REQUEST FOR INFORMATION NOT ADDRESSED IN THIS CCO REMAIN IN FORCE					
2	03/26/10	DEHUMIDIFIER SCADA INTERFACE	RR	RG FW	130
1	02/25/08	CABLE TRAY CHANGES	TW	RG SE	42S1
MARK	DATE	DESCRIPTIONS	BY	CH'D	CCO#
		REVISIONS

CONTRACT CHANGE ORDER NO._____
SHEET _____ OF _____

DETAILS
SAS SUPERSTRUCTURE ROADWAY WESTBOUND DEHUMIDIFIER UNIT 1
SCALE AS NOTED

E-79

DEHUMIDIFICATION PLAN
NO SCALE

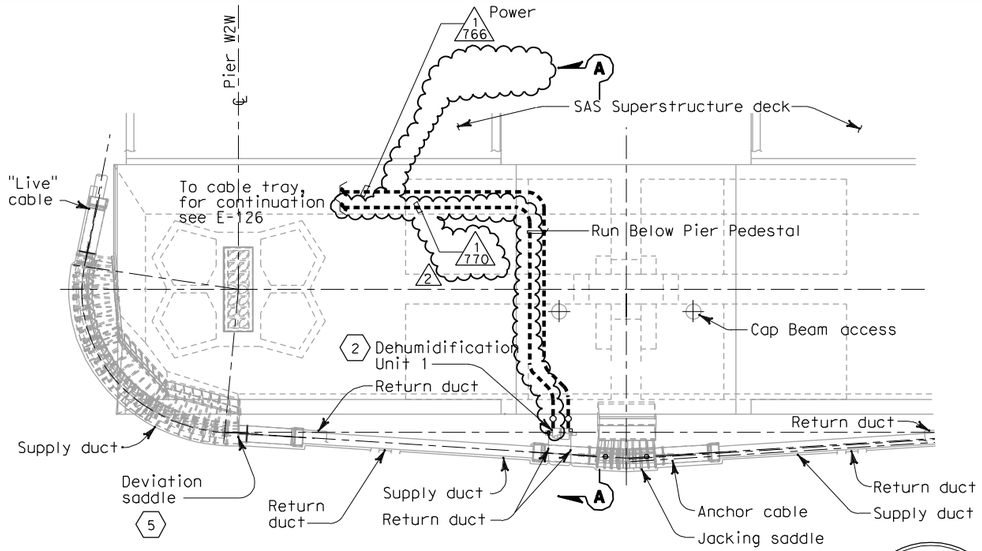
1. Route power and ~~TOS/COM~~ 2 conduits and cables ~~from dehumidifier to cable trays 1T29 and 1T49 respectively below the girder for circuits #1115 and #1115-1.~~ 2
2. Dehumidification Unit 1 is 480 V, 3 phase, 16 kW (estimated load) with integral circuit breaker disconnect.
3. Final connections to dehumidifier shall be liquid tight flexible metal conduit.
4. ~~For pull boxes information, see pull boxes schedule sheet E-83.~~ 2
5. Views of Deviation Saddle are for illustration only. For Deviation Saddle details, see "West Deviation Saddle Details" sheets.
